RESOLUTION NO. 24069

A RESOLUTION APPROVING A PRELIMINARY PLANNED UNIT DEVELOPMENT SPECIAL EXCEPTIONS PERMIT FOR A PROPOSED PLANNED UNIT DEVELOPMENT KNOWN AS IRISH KNOLL PLANNED UNIT DEVELOPMENT, ON A TRACT OF LAND LOCATED IN THE 6600 BLOCK OF SANDSWITCH ROAD, MORE PARTICULARLY DESCRIBED HEREIN AND AS SHOWN ON THE MAP ATTACHED HERETO AND MADE A PART HEREOF BY REFERENCE, SUBJECT TO CERTAIN CONDITIONS.

SUBDIVISION: Irish Knoll Planned Unit Development
Lots 1-64

STATUS: Preliminary Planned Unit Development Plan

2004-023

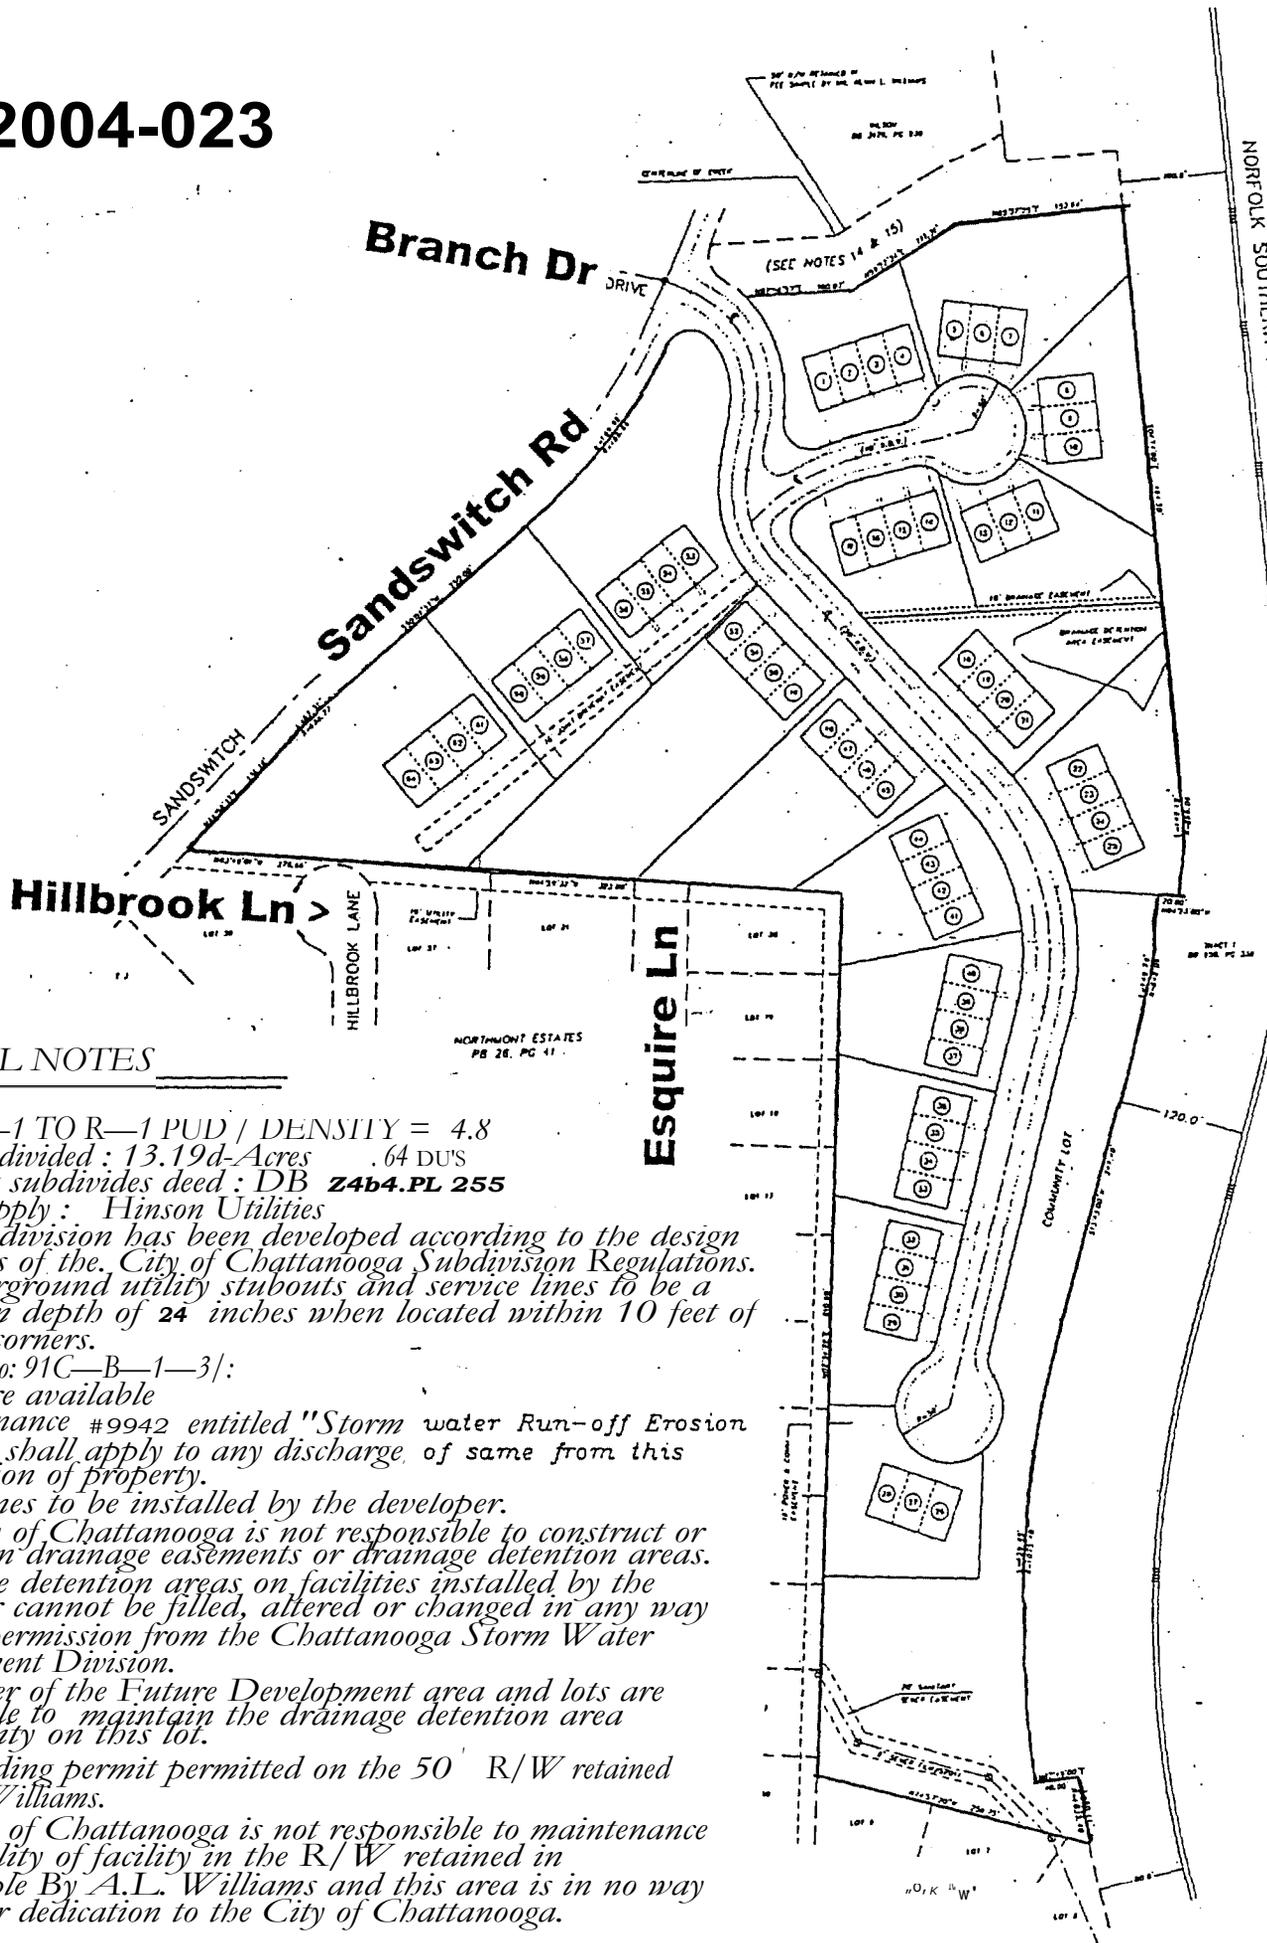
- 1) The property adjacent to the area included in the plan will not be adversely affected.
- 2) The plan is consistent with the intent and purpose of the **Chattanooga** Zoning Ordinance to promote public health, safety, morals and general welfare.
- 3) The buildings shall be used only for single-family, two-family dwellings, or multi-family dwellings, and the usual accessory uses such as private or storage garages, storage space, and for community activities, including school and/or churches.
- 4) There is a need for such development in the proposed location.
- 5) There is a reasonable assurance that development will proceed according to the spirit and letter of the approved plans.

1. Indicate the surrounding type of development and land use.
2. Per requirements of the Chattanooga Zoning Ordinance, submit sewer plans and profiles and road profiles.
3. The Chattanooga Zoning Ordinance requires at least two off-street parking spaces per unit for townhouses and three off-street parking spaces per unit for townhouse units with four or more bedrooms. Indicate by note the number of bedrooms in units. If all units will have three or less bedrooms, indicate such by note. Indicate the number of units to have four or more bedrooms.

4. Change the typical building design to indicate the number of off-area parking spaces at each unit.
5. When lots are to be sold, roads in a P.U.D. must be built to the standards of the **Chattanooga** Subdivision Regulations. The Chattanooga Subdivision Regulations only permit a 40' road right-of-way for short cul-de-sacs serving ten or less lots. Since 17 lots are served by the cul-de-sac at lots 1-17, increase the 40' right-of-way to 50'.
6. Article V, Section 1208 (3) of the Chattanooga Zoning Ordinance concerning site improvements in a planned unit development reads as follows:

7. Show the location of sidewalks or equivalent paved internal pedestrian circulation required above.
8. Change the adjoining street from Long Branch Drive to Branch Drive.

9. Give the Community Lot a lot number.
10. Per the Chattanooga Fire Department, show on the plat and install a fire hydrant in lot 17 at the intersection or in lot 53 just north of the 16' front driveway easement on the same side of the road as the water line.

11. Per the Chattanooga Fire Department, show on the plat and install a fire hydrant at the lot line between lots 36 and 37 or across the road from Church on the same side of the road as the water line.

12. Show the location and file number of any existing sewer line in Sandwitch Road.
13. Submit sea level contour lines with the final P.U.D. plans.
14. Show the size, location and number of acres drained for drainage pipes in roads. All drainage pipes under pavement or sidewalk areas must be reinforced concrete (RCP).

15. Since there are more than 25 lots, two boundary control monuments must be located to an accuracy of 1:20,000 in state plane coordinates. Show the location and state plane coordinates of these two boundary monuments on the final P.U.D. plan.

1. The Chattanooga City, Engineer has recently determined drainage detention must be on community lots jointly owned by lot owners in the subdivision from which the drainage comes and that these lot owners must be responsible for maintenance costs of drainage detention areas. Ownership by the property owners association is not acceptable because property owners associations can go bankrupt or otherwise become non-functional. The deed restrictions must reflect that each lot owner is part owner of the community lot used for drainage detention and agrees to pay their fair share of the maintenance costs.

Show a separate lot for the drainage detention area and give it a lot number. This lot must front at least 25' on a road.

3. Due to the absence of contour lines, a drainage plan and drainage calculations, there is not sufficient information for a drainage review.
4. Due to the absence of a sewer plan and sewer profile, there is not sufficient information for a sewer review.
5. Due to the absence of a road profile, there is not sufficient information for a review of the proposed roads.
6. Questions about Chattanooga City Engineer's Office requirements should be directed to Mr. Joel Booth at 757-4886.

1. Show a 10' power and communication easement along both sides of new roads.
2. Show a 5' power and communication easement along Sandwich Road.
3. Show a 20' power and communication easement along the lot line between lots 28 and 29.
